IB188

Release Bearing Installation

Chevrolet and GMC applications, 1995 and older.

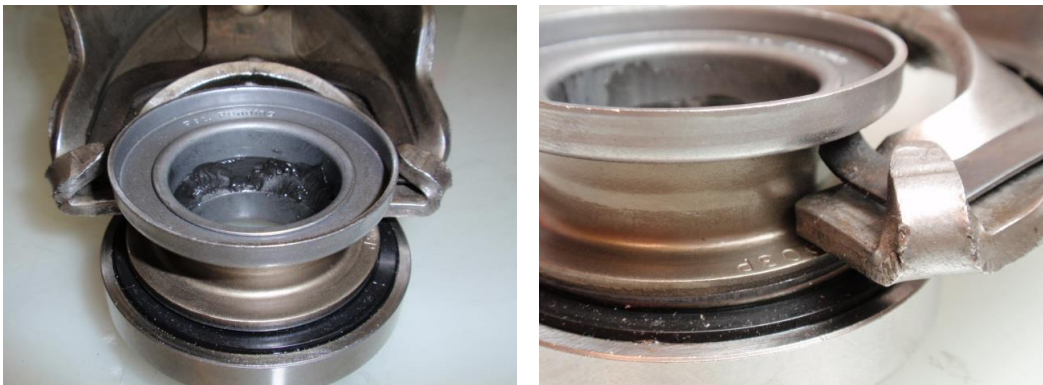
The clutch release fork spring tabs must be installed under the rear flange of the bearing, never behind the rear flange. Incorrectly installed will cause:

1. The clutch will not release correctly.
2. Release bearing and clutch fork may be damaged.
3. Mechanical or hydraulic release system components may also be damaged.

Effective with clutch kits starting in early 2015 a revised bearing design has been introduced to eliminate the possibility of incorrectly installing the bearing on the fork. The revised bearing has a cup on the rear flange that will not allow the fork spring tabs to be installed wrong. Patent Pending.
